**REPORT ON INDEPENDENT
ANALYSIS AND ADVICE
REGARDING THE SAFETY CASE**

Doel 3

Reactor Pressure Vessel Assessment

Electrabel
GDF SUEZ

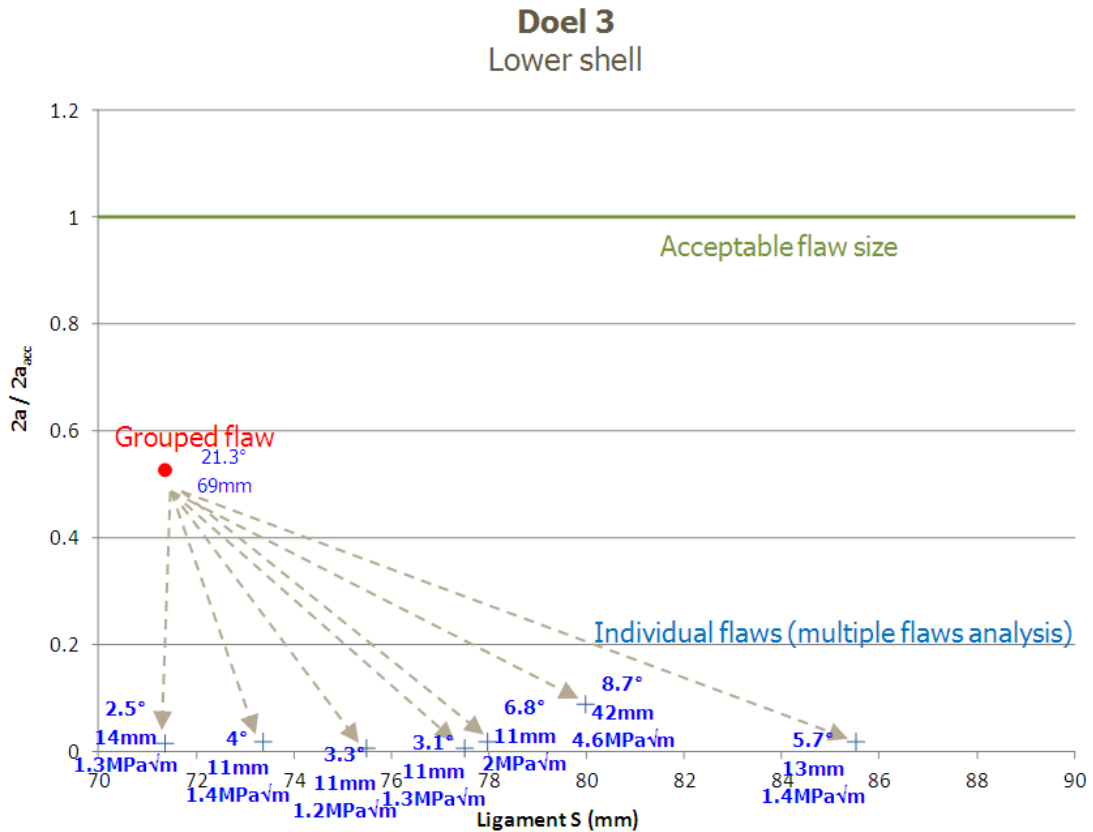
The Project Team has developed alternative grouping criteria applicable to laminar and nearly laminar flaws. The proposed methodology relies on the assumption that interacting flaws can be replaced by a single equivalent flaw that encompasses the volume of all the flaws in the group of interacting flaws and that this equivalent flaw will result in an equivalent or more conservative estimation of the fracture behaviour of the group of flaws it represents. Flaws are considered to be interacting when an increase in the stress intensity factor for one flaw caused by the presence of a second flaw equals or exceeds 6 %.

For various flaw sizes and orientations, grouping criteria are established. Based on these grouping criteria, each flaw is evaluated to determine whether it should be grouped with neighbouring flaws before being evaluated for flaw fracture initiation.

Once all flaws have been assessed according to the grouping criteria and have been classified either as stand-alone flaws or grouped flaws, they are evaluated in isolation against allowable flaw size envelope curves.

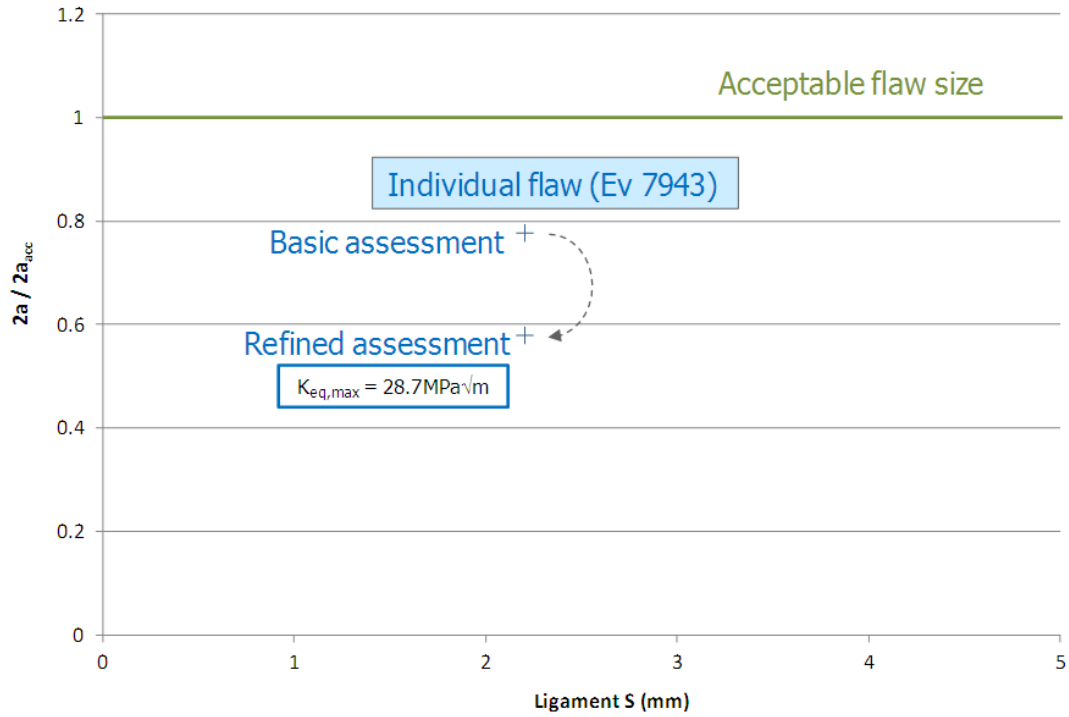
Based on the alternative grouping procedure, any flaw that experiences an increase in its equivalent stress intensity factor of less than 6 % due to the presence of any single neighbouring flaw (each evaluated individually) can be considered in isolation when determining its fracture behaviour.

SNL has shown that considering such flaws in isolation can be non-conservative for some configurations of closely-spaced flaws. SNL recommended that flaws that have been deemed acceptable in isolation by the Project Team be reassessed in light of the effect that neighbouring flaws may have on them. In order to address this concern, the Project Team assessed the influence of the environment on ungrouped flaws through 3D analysis of the two individual flaws closest to the maximum available size. One result is shown in the picture below where the refined assessment shows a significant additional margin:

In light of the results, SNL concludes that the Project Team approach is reasonable and that it will ensure the adequacy of the methodology. The SCP Review Team agrees with this conclusion.

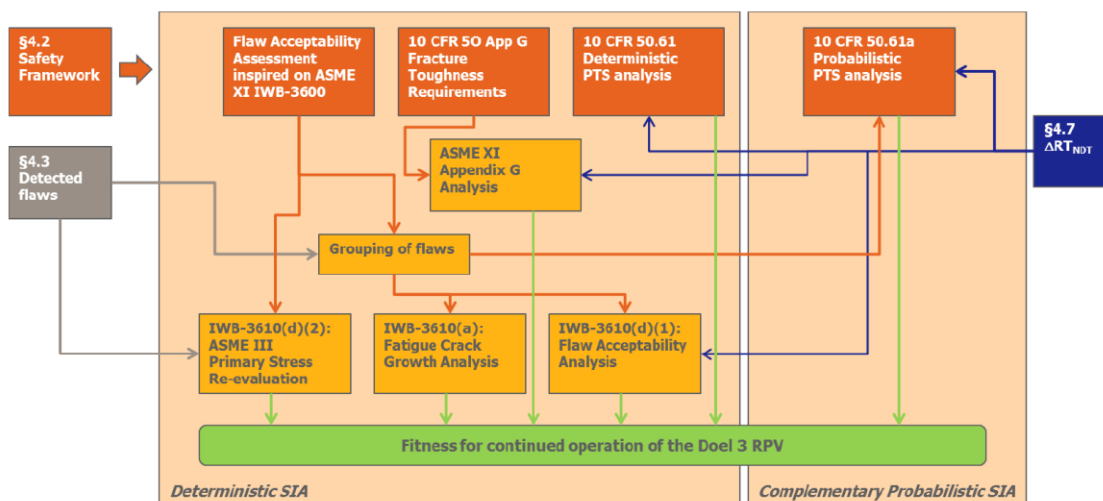
The SCP Review Team endorses the conclusion of the Project Team that the flaw growth is very limited and need not be taken into consideration for further calculations.

The Project Team conclusion is based on:

- The accepted root cause analysis (hydrogen flakes being the identified root cause).
- The mechanisms related to hydrogen flakes (among others, hydrogen-induced cracking).
- The very limited number of transients with respect to the usual number of cycles considered for the fatigue simulations, hence in the low cycle part of the fatigue curve.
- The accepted value of the growth rate for the low cycle fatigue phenomenon.
- The fact that the material between flaws is sound.
- The selection of the envelope flaw to calculate the flaw growth.

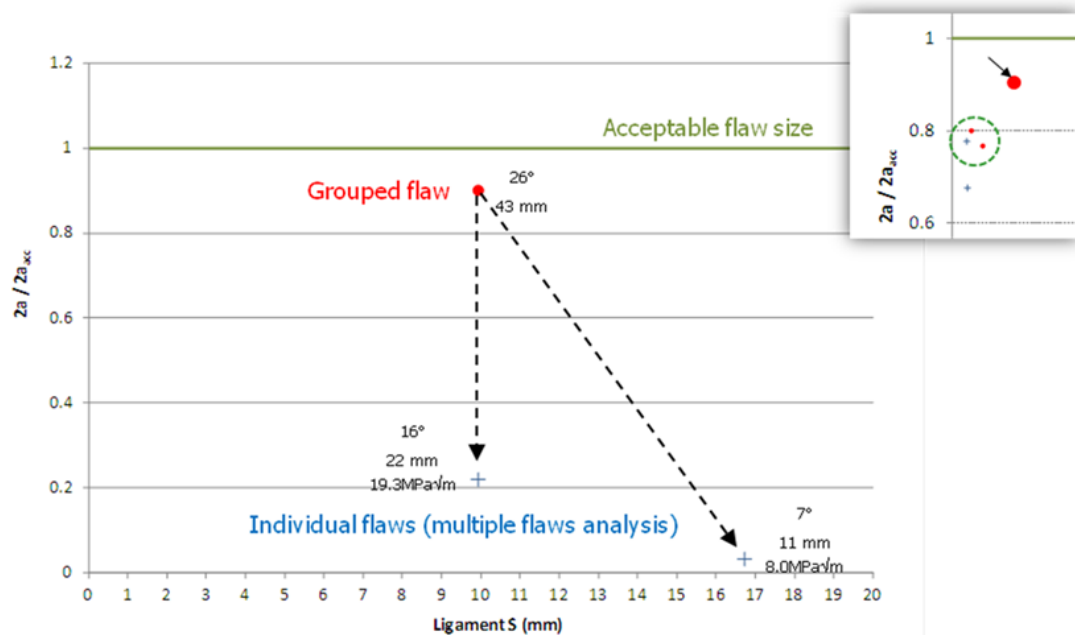
SCP Review Team thoroughly challenged the Project Team regarding the modified ASME XI flaw assessment methodology. The most important concerns of the SCP Review Team were about how to conservatively apply the proposed grouping criteria and how to take into account the effect of the surrounding flaws on the isolated flaw.

The Project Team has clearly demonstrated that the only cases for which this question was relevant were acceptable. The relevant cases are the ones in which the flaws (grouped or isolated) are close to the maximum allowable size before facing a crack initiation risk, according to the ASME values. For the flaws close to this limit value, calculations have been made by the Project Team to quantify the impact of the grouping criteria and the surrounding flaws. To perform those calculations, the grouped flaws have been un-grouped. The set of un-grouped flaws has been evaluated through 3D calculations. The results were completely satisfactory, showing that the grouping criteria used were acceptable and offered a large margin versus allowable size, as shown in the graph below.

Similar 3D calculations were performed for the most critical isolated flaw, with similar results. The potential lack of conservativeness due to the neglected influence of the surrounding flaws on the calculated flaw, was largely compensated for by the over-conservativeness of the flaw grouping methodology.
